RE: Sufficiency Review for Miscellaneous Application for Northern South Park Area 1 Master Site Plan

Northern South Park Area 1 Master Site Plan Submittal

Exhibit A: Concept Map and Planning Concept Map

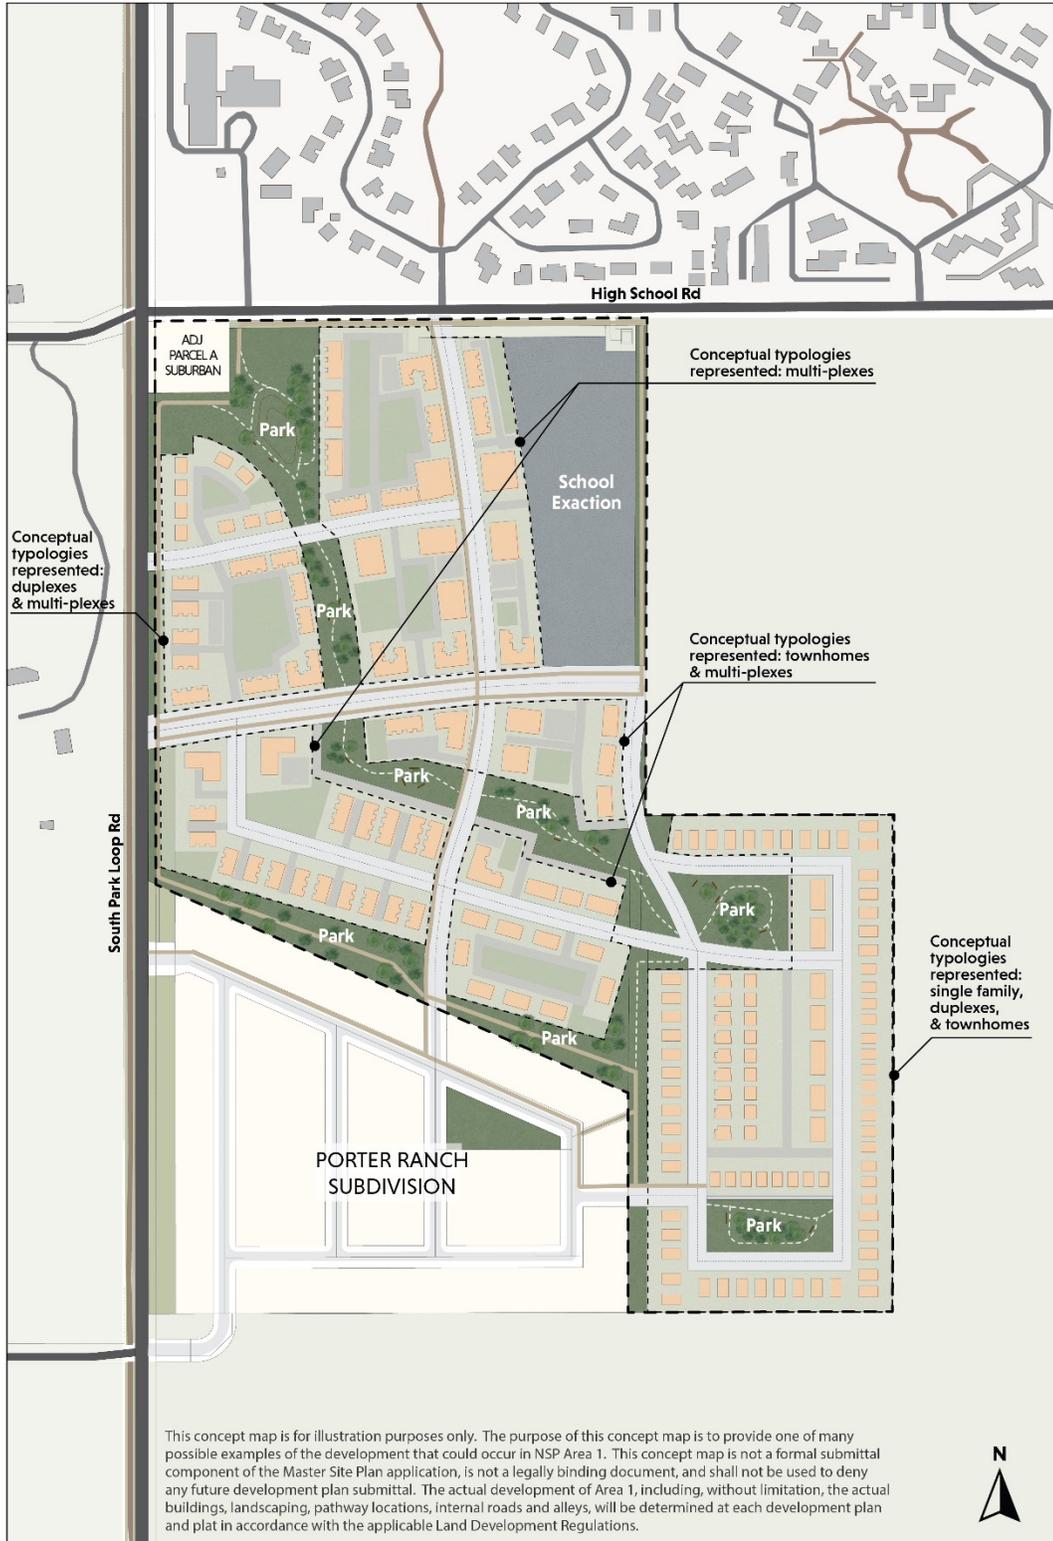
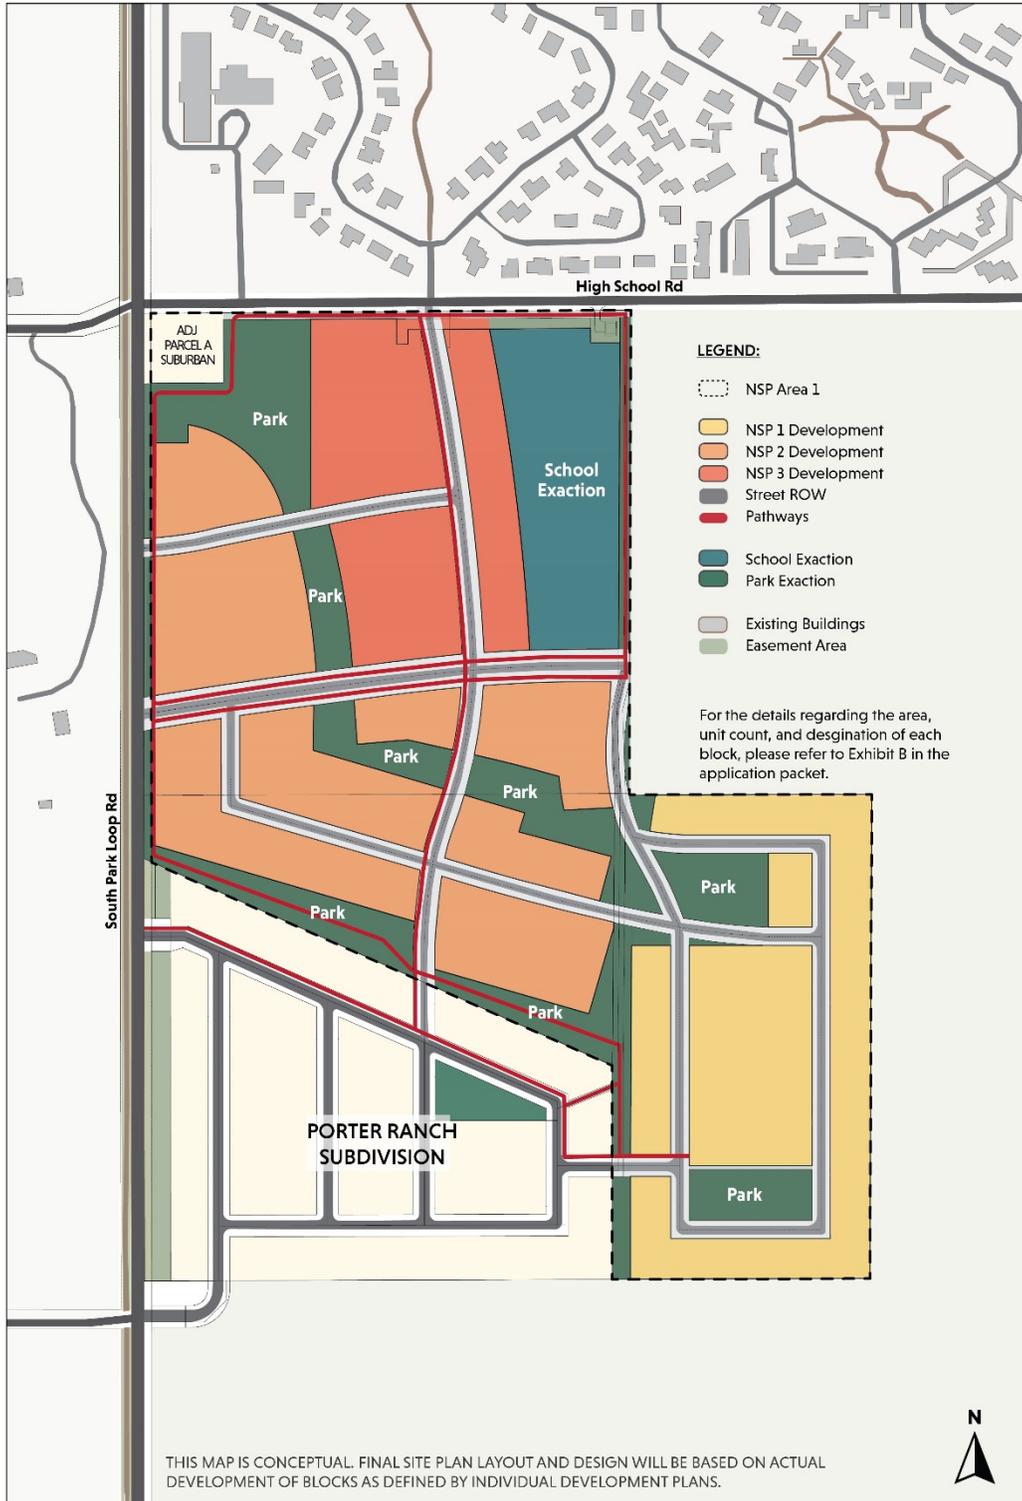
The LDRs do not require detailed building types by block, even conceptually. However, we have designated each block with the three NSP standards (NSP-1, NSP-2 or NSP-3). The LDRs then provide the housing types that may be built with each of those standards (NSP-1, NSP-2 and NSP-3). Please see the maps in the application, which designate the NSP standard for each block. Even though conceptual building types by block is not required by the LDRs, and is not a reason for the

application to be insufficient, we have annotated Exhibit A to our application to show potential housing types.
